Tech Tips

TT 40-16-01

2013-2016 CC - Knocking Noise from Vehicle Front, Typically occurs only one time after each direction change (forward or backward, left or right)

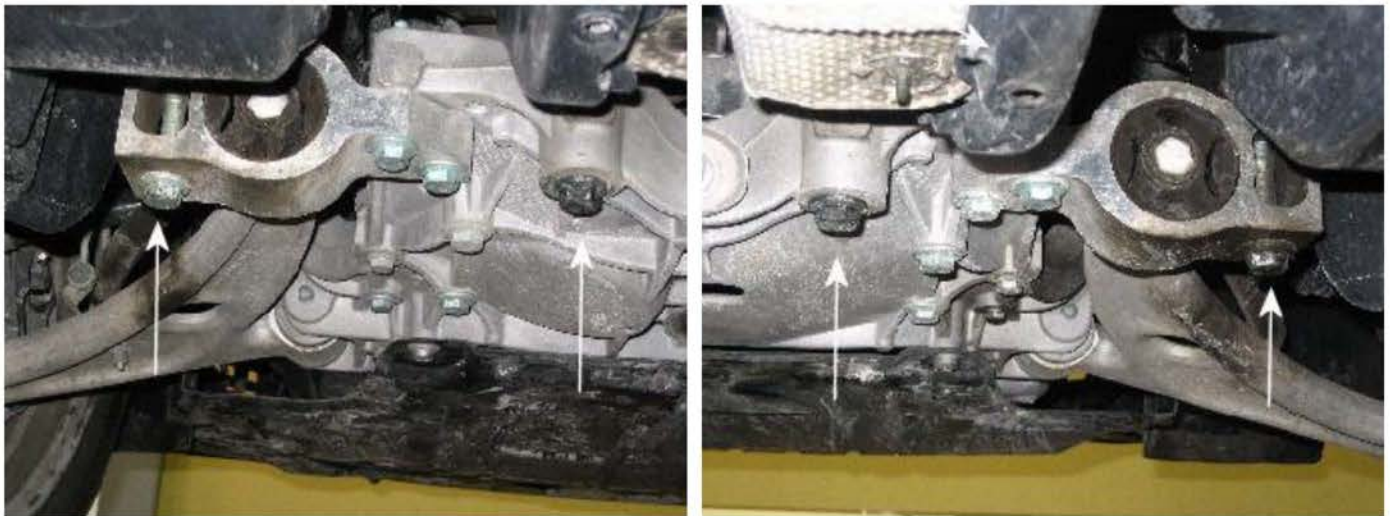
If this concern is identified, inspect to see if the two specialty plates (washers), Part No: 7M3499349A, is installed between the sub frame and body. If not, please perform the following:

- Loosen by two turns, the four bolts towards the rear of the sub frame.
- Remove one inboard bolt.

- Insert washer Part No. 7M3499349A between sub frame and body, centered on the hole with tabs of washer pointing rear and down as shown.
- Insert a new bolt and hand tighten.
- Repeat the above procedure with second inboard bolt.
- Tighten all 4 bolts, in accordance to Repair Manual Group 40 Front suspension, driveshaft in ElsaWeb
